600 VOLT MOTOR CONTROL CENTRE – MCC-2G

CONSULTANT DRAWING NO. 870012-01-20-G-E109

SOUTH END WATER POLLUTION CONTROL CENTRE  
PUMP & SCREEN BUILDING – ELECTRICAL  
MOTOR CONTROL CENTRE 2G

SEP-830

MCC-2G – FRONT ELEVATION

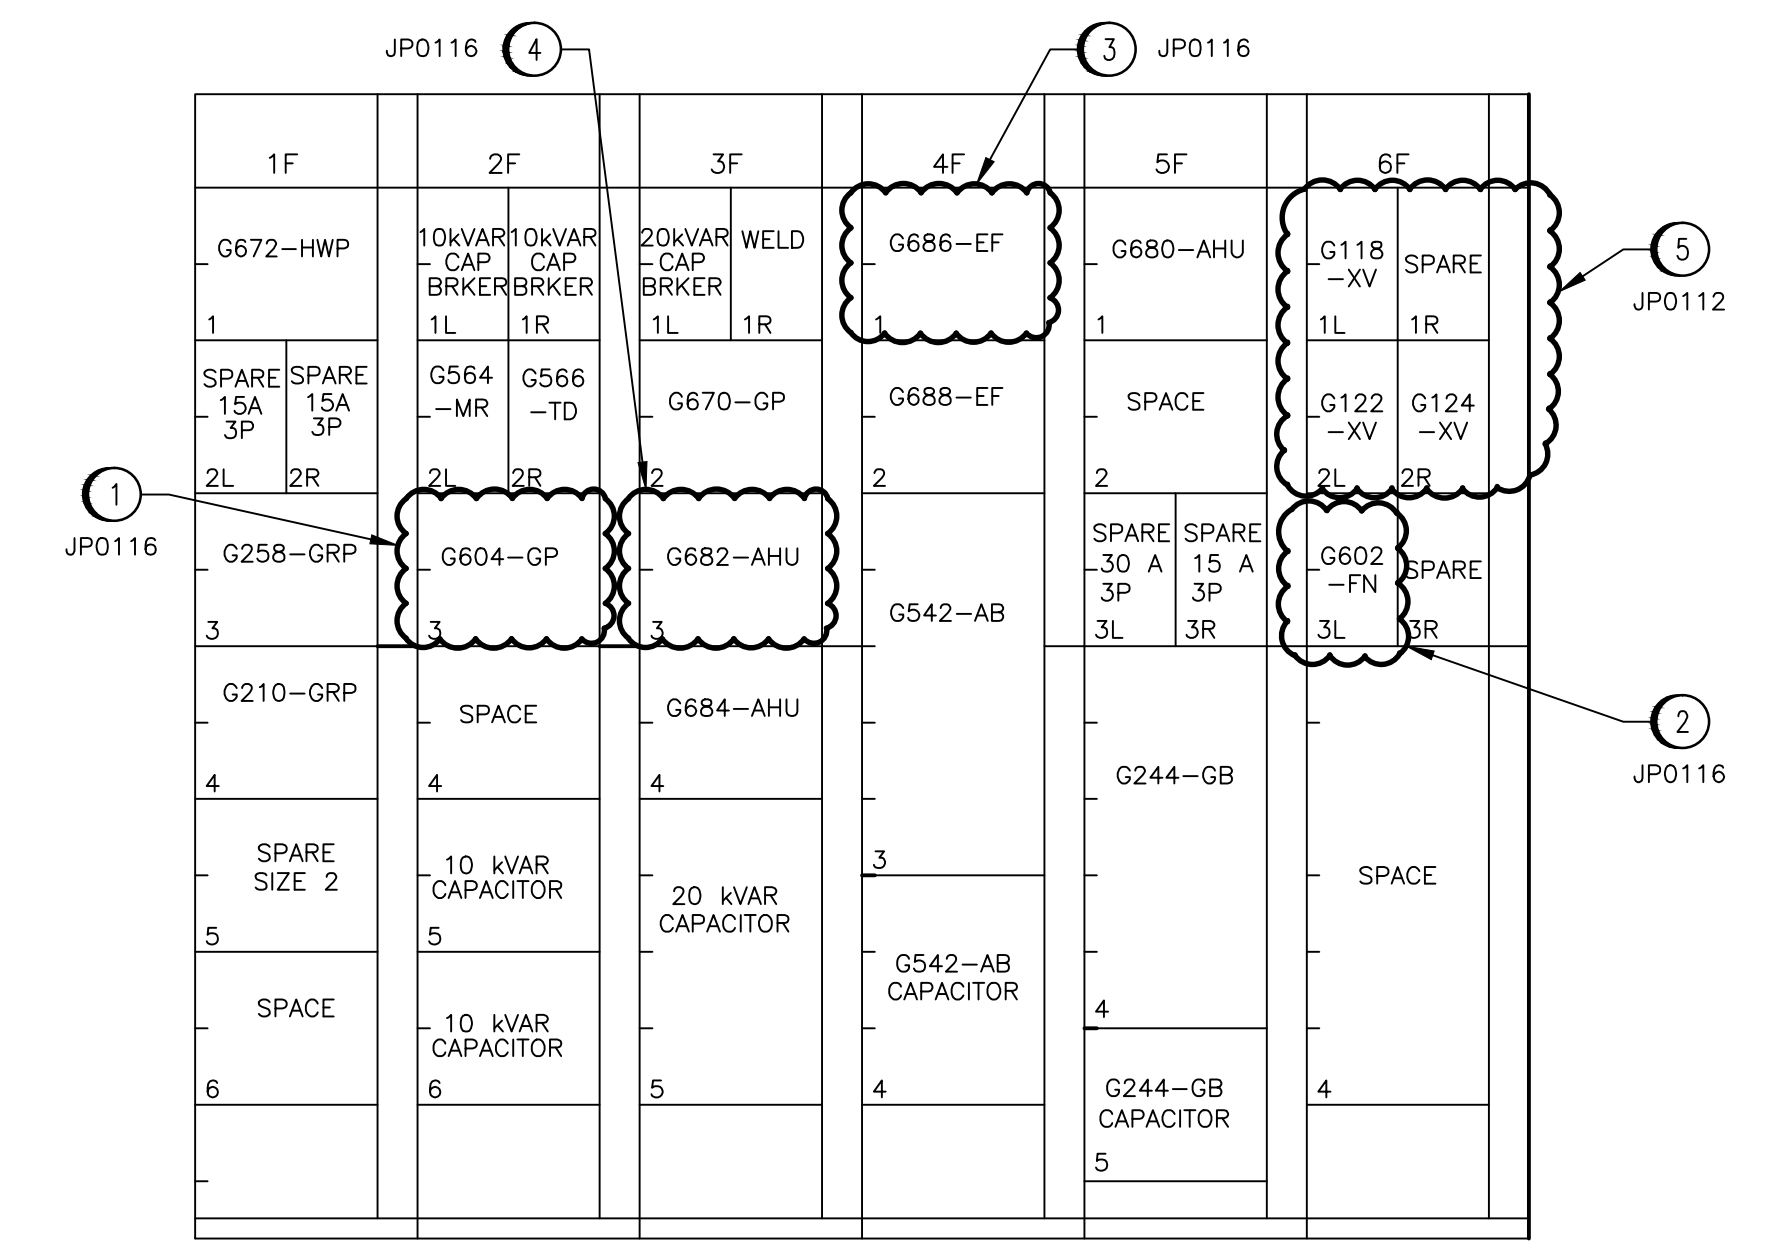
- USE EXISTING SPARE MCC BUCKET FOR G604-GP AND REWIRE AS SHOWN ON SCHEMATIC DRAWING.
- INSTALL FUSED DISCONNECT FOR VFD FOR G602-FN.
- REPLACE EXISTING MCC BUCKET FOR G686-EF AND REWIRE AS SHOWN ON SCHEMATIC DRAWING.
- RE-USE EXISTING MCC BUCKET FOR G682-AHU AND REWIRE AS SHOWN ON SCHEMATIC DRAWING.

- INSTALL CIRCUIT BREAKERS FOR VALVE ACTUATORS.

3	ADDED BREAKERS FOR ACTUATORS	2010/09/01	TMC
2	ADDED UNDERVOLTAGE PROTECTION TO MCC-2G	12/09	NB
1	AS CONSTRUCTED	08/03	B.T.
0	ISSUED FOR TENDER	12/91	B.T.
-	ISSUED FOR CITY REVIEW	05/91	B.T.
